# Technical Service Bulletin

<b>GROUP</b>	<b>NUMBER</b>
<b>RECALL</b>	<b>25-01-004G</b>
<b>DATE</b>	<b>MODEL(S)</b>
<b>JANUARY 2025</b>	<b>G70 (IK) G80 (DH) G90 (HI)</b>

**SUBJECT:** STARTER RELAY KIT INSTALLATION (RECALL 018G)

This TSB supersedes 24-01-058G to enhance Starter Relay Kit Installation step 9 on page 15.

Current Configuration	New Starter Relay Kit Installation

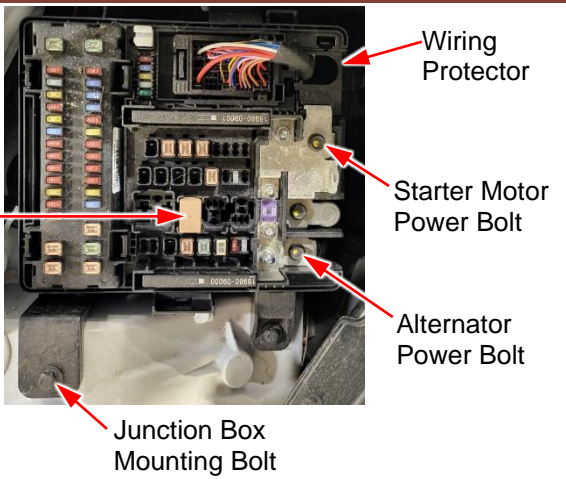
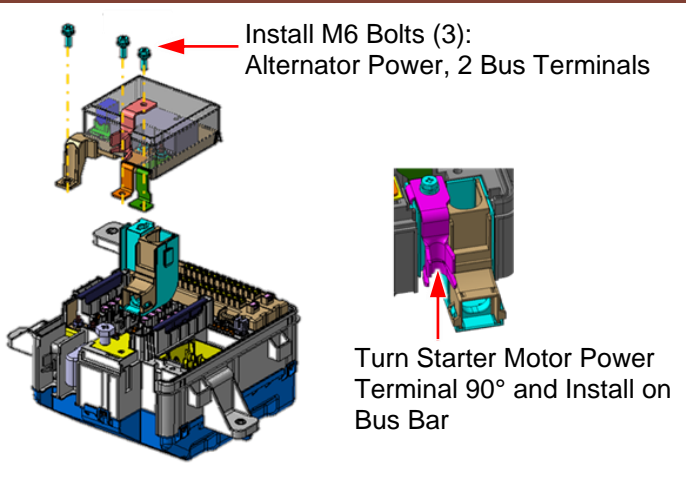
**Description:** Certain 2019MY G70 (IK), 2017-2019MY G80 (DH), and 2017-2019MY G90 (HI) vehicles may exhibit starter damage while parked or driving in abnormally wet conditions, such as a flooded road. This may be due to moisture contamination within the starter solenoid causing an electrical short over time. Follow the procedure in this TSB to install a new starter relay kit in the engine room junction box, and to replace the upper cover and upper cover label.

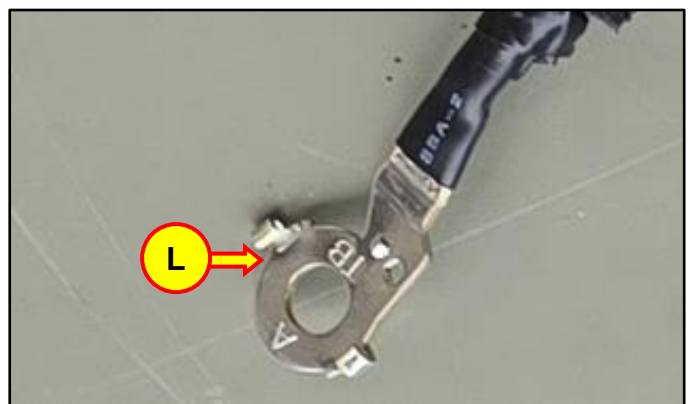
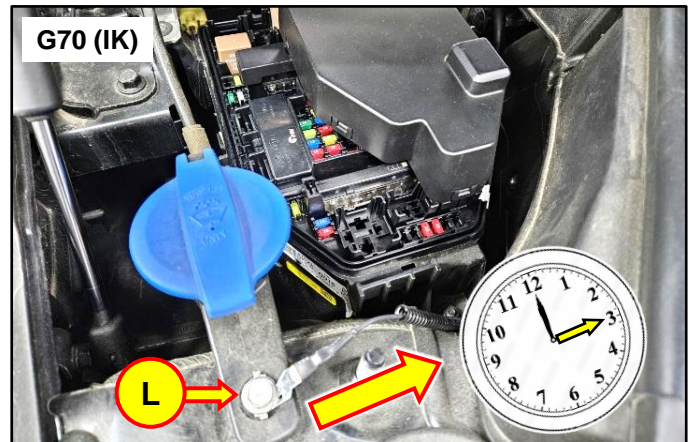
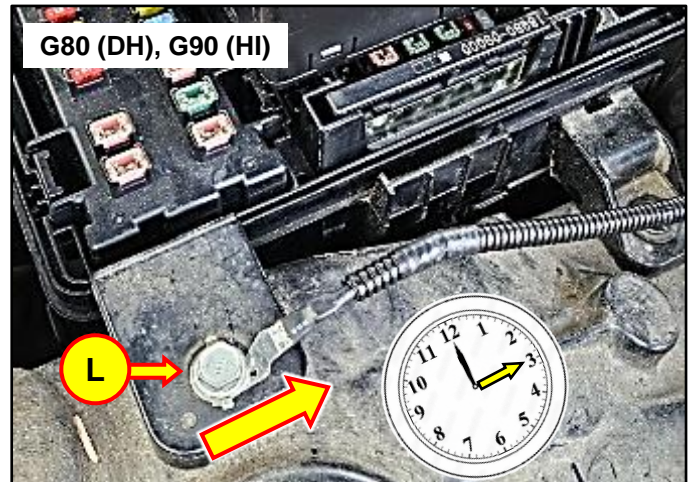
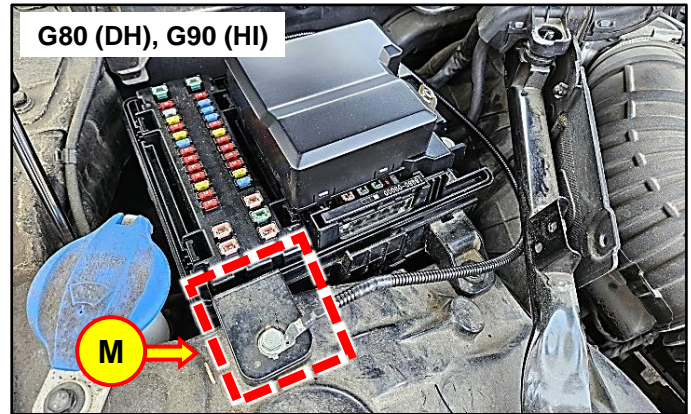
9. Discard the original junction box mounting bolt and use the provided ground bolt (circled right) to install the extension ground terminal (L) from the new relay kit using the existing junction box mounting location (M).

**Tightening Torque:**

lb-ft	0.9
lb-in	10.8
N.m	1.2

Do **NOT** exceed the tightening torque above. This may damage the part.

Be sure to install the ground terminal with the protrusion facing up to prevent damaging the terminal.

The ground harness should be installed in the **3 o'clock** position, as shown.
